MAINE YANKEE ATOMIC POWER COMPANY

ANNUAL RADIOACTIVE EFFLUENT RELEASE REPORT

January-December 2002

Changes to the ODCM made during the year 2002 are summarized in Appendix E. A complete copy of the revised manual is attached as well as the specific pages that changed.

FIGURE 5.1

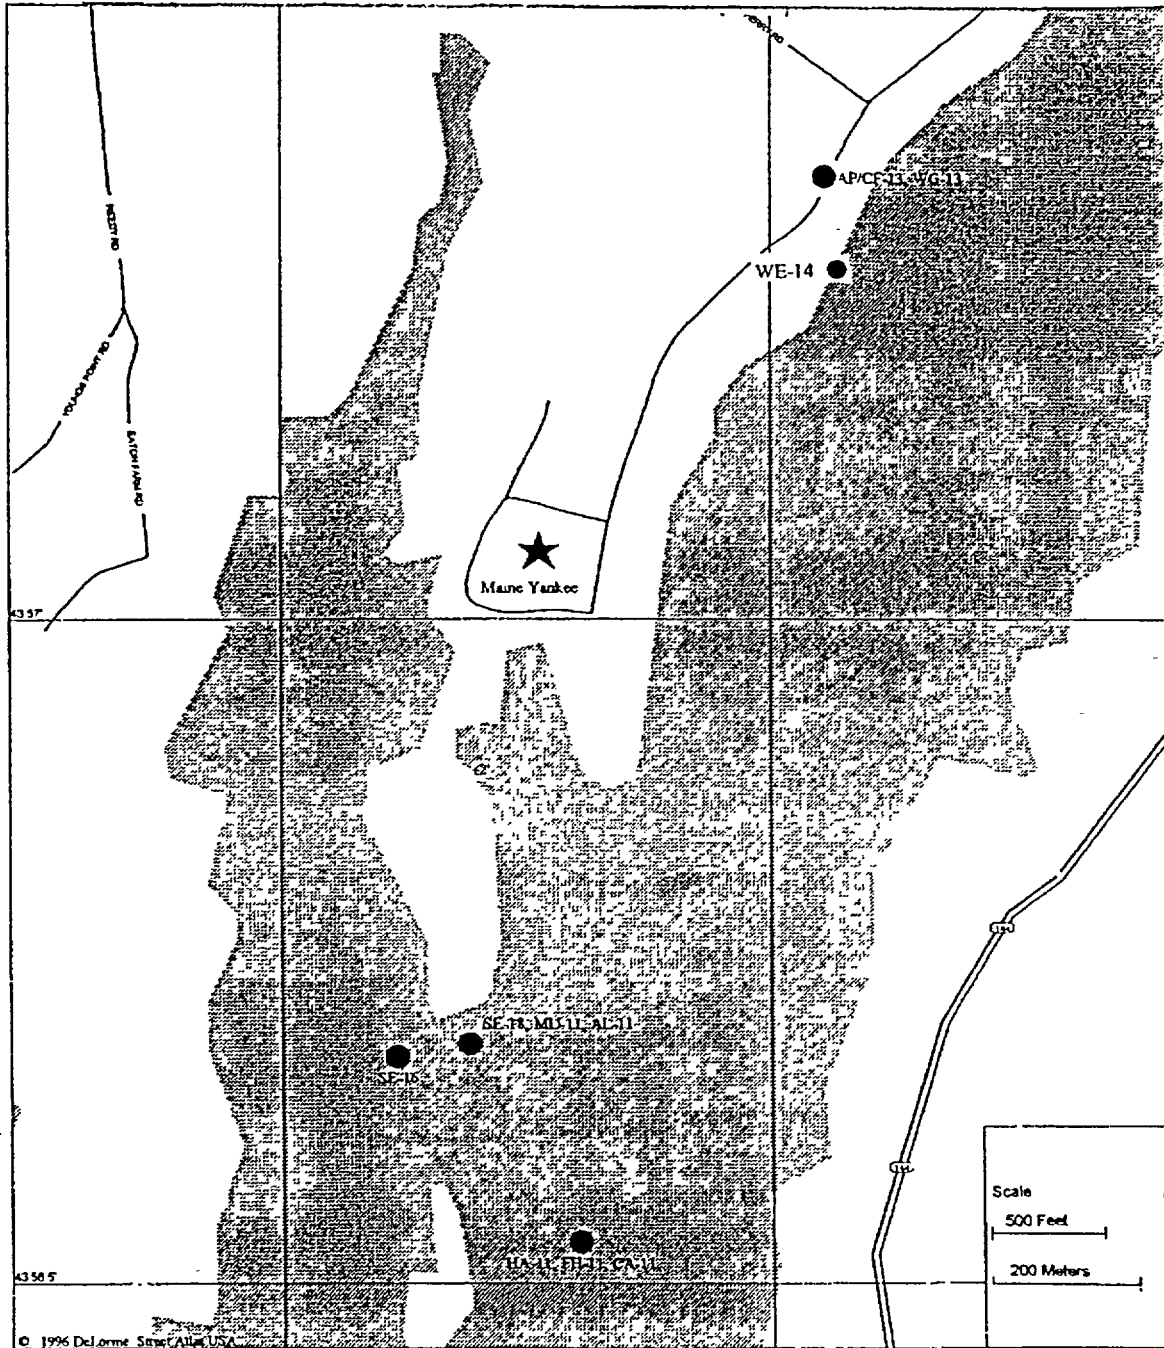
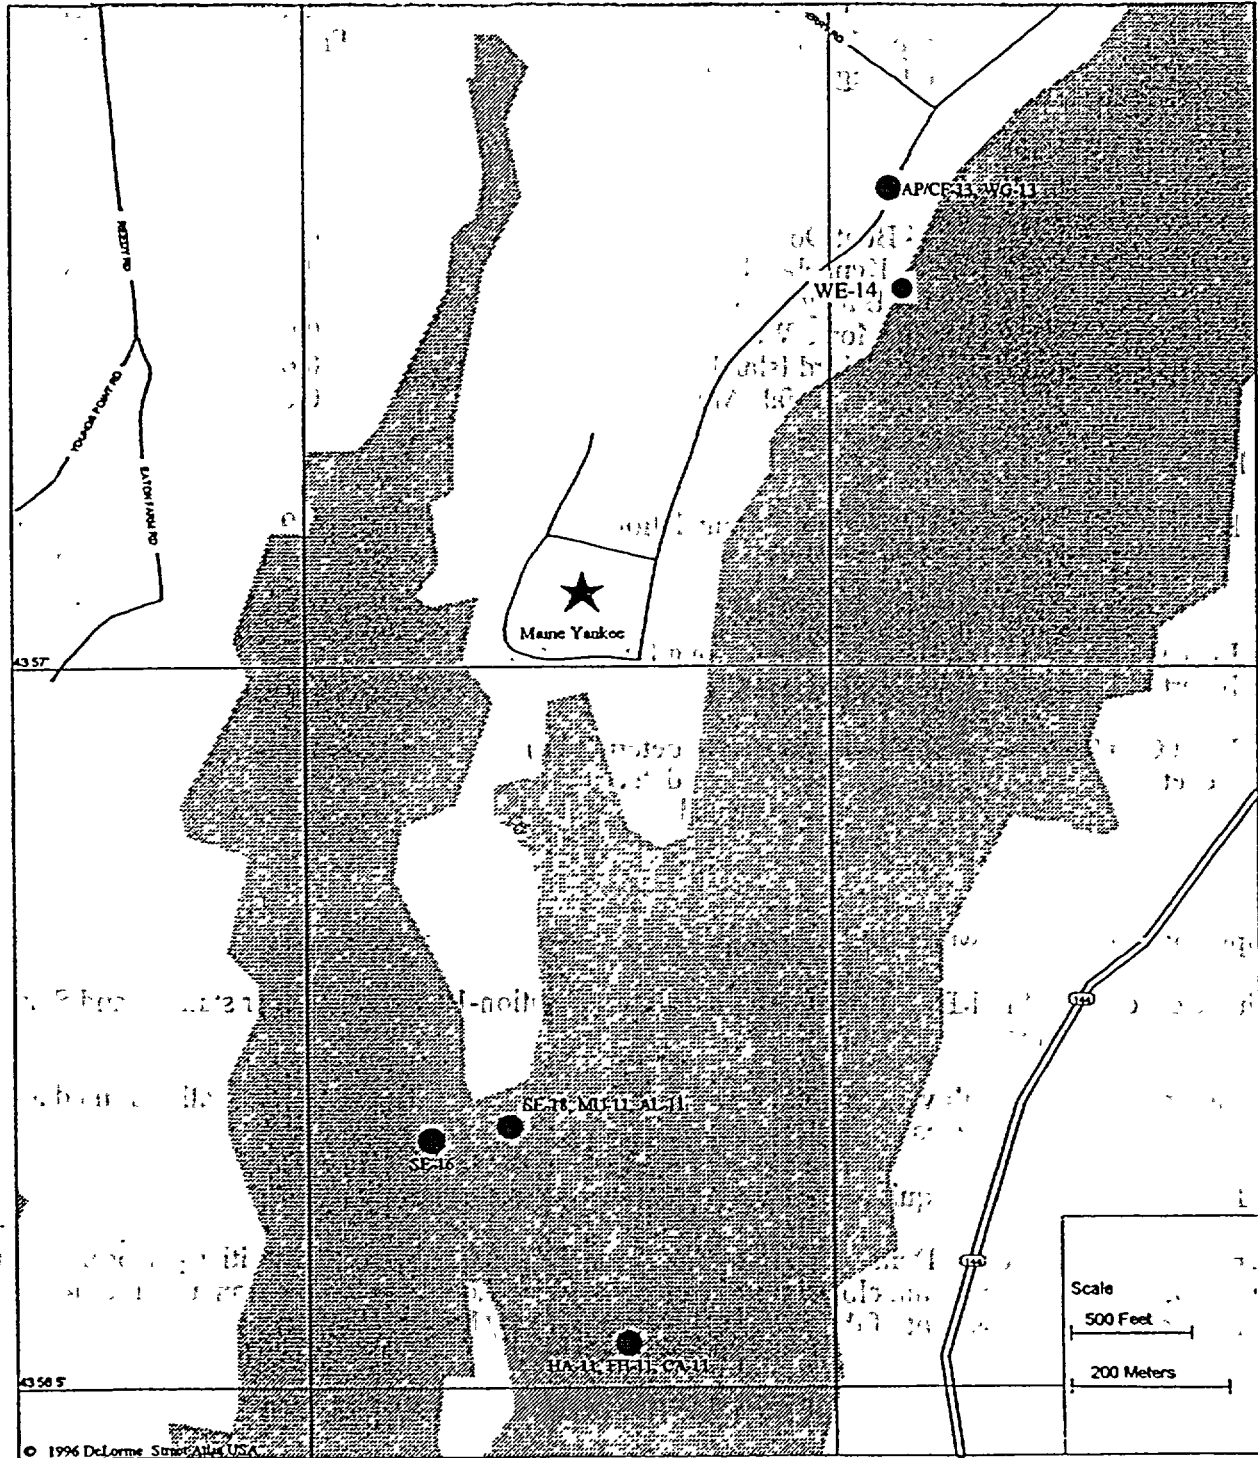
Summary: Sections 2.1.4, 3.1.1, 3.1.2, Tables 2 3, 2.6, 3 1, 5.1, Figure 5.1 and Appendix A were all revised to eliminate the use of the Forebay from a licensed release path and incorporated the new liquid waste discharge path to the back river. Justification for this change is contained within Calculation MYC-2083 Rev 1.

Summary: Sections 2.1.4, 3.1.1, 3.1.2, Tables 2.3, 2.6, 3.1, 5.1, Figure 5.1 and Appendix A were all revised to eliminate the use of the Forebay from a licensed release path and incorporated the new liquid waste discharge path to the back river. Justification for this change is contained within Calculation MYC-2083 Rev.1.

FIGURE 6.2

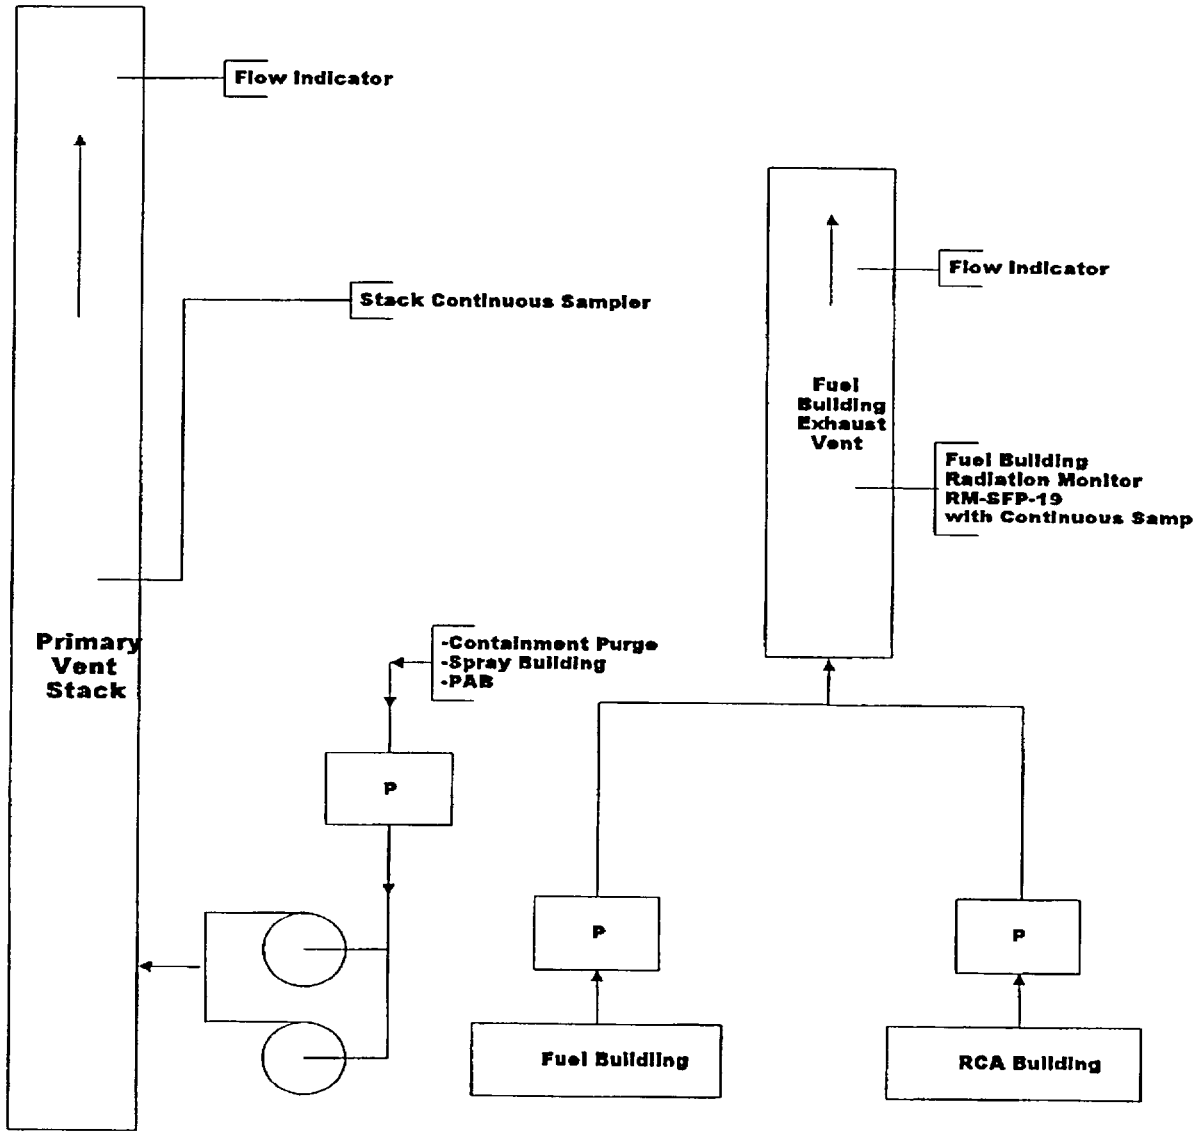
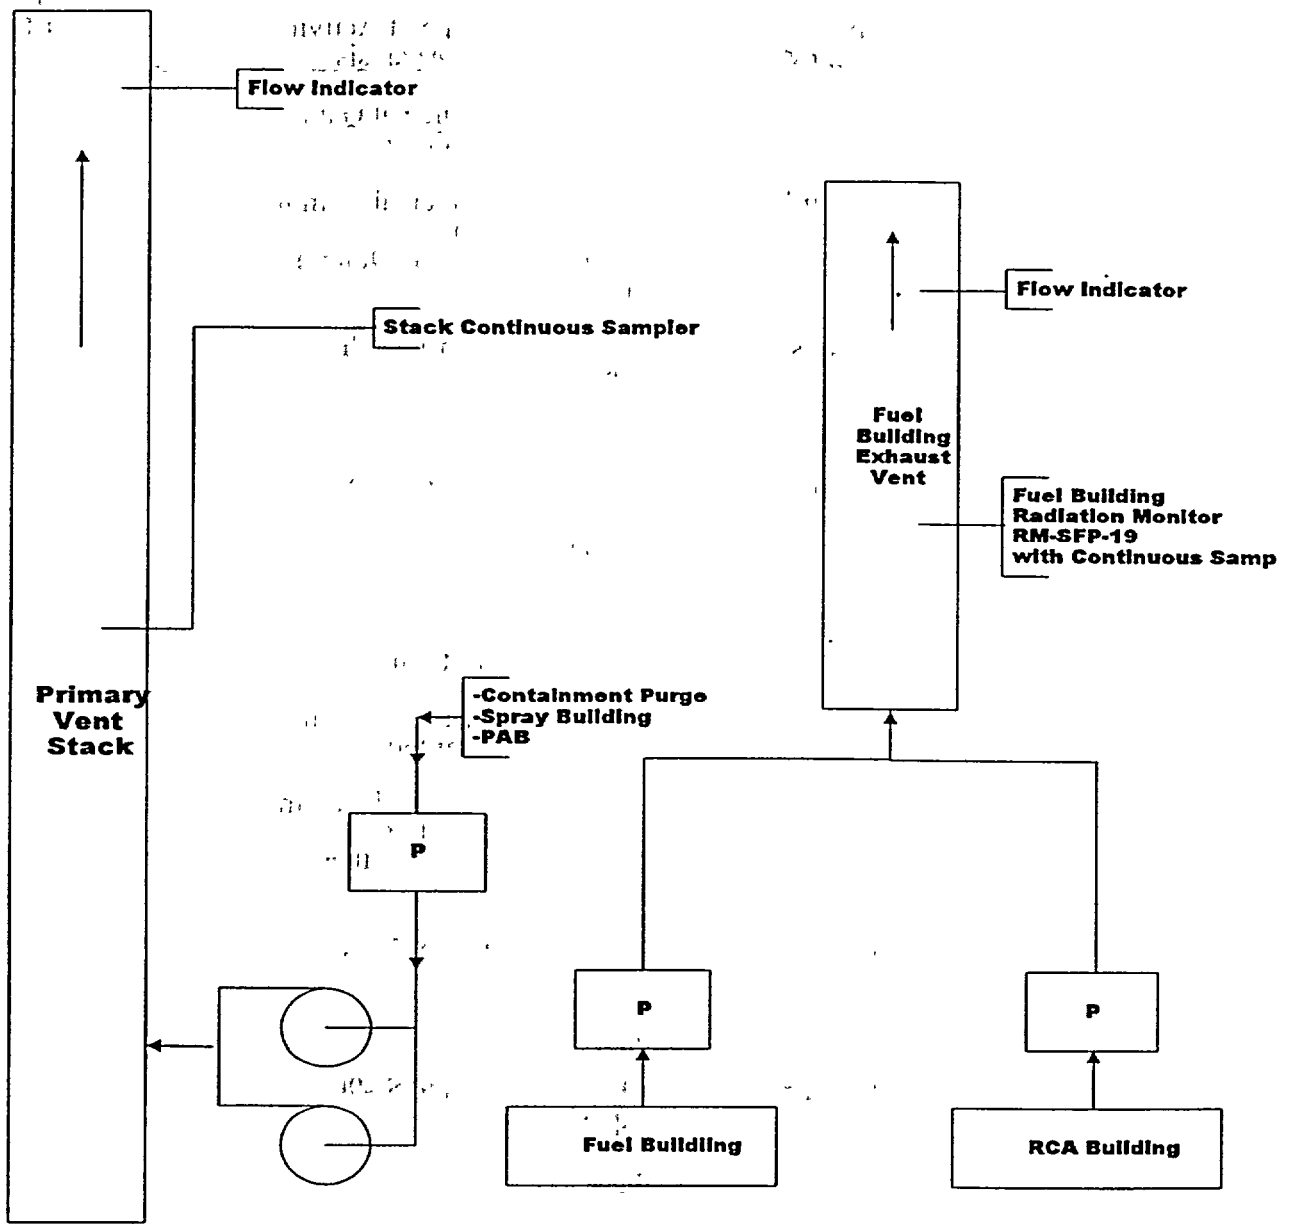
[Routine particulate samples are collected in Zone I and II. In addition, sampling is performed in locations in Zone I when a building is no longer tied into existing ventilation systems as described in the ODCM Figure 6.2, Maine Yankee Gaseous Radwaste Treatment System, has large permanent openings to the environment, and is subject to active demolition activities. Demolition occurs after source term has been removed from these buildings and decontamination performed as necessary. No significant effluent release is expected during demolition activities. The number and location of sampling points is dependent on the activities performed. Air samplers are placed in or within close proximity of buildings undergoing demolition activities to provide reasonably assessment of the airborne activity that may be generated. Sampling during demolition activities is performed to validate models and assumptions used to bound demolition effluent releases.

Routine particulate samples are collected in Zone I and II. In addition, sampling is performed in locations in Zone I when a building is no longer tied into existing ventilation systems as described in the ODCM Figure 6.2, Maine Yankee Gaseous Radwaste Treatment System, has large permanent openings to the environment, and is subject to active demolition activities. Demolition occurs after source term has been removed from these buildings and decontamination performed as necessary. No significant effluent release is expected during demolition activities. The number and location of sampling points is dependent on the activities performed. Air samplers are placed in or within close proximity of buildings undergoing demolition activities to provide reasonably assessment of the airborne activity that may be generated. Sampling during demolition activities is performed to validate models and assumptions used to bound demolition effluent releases.
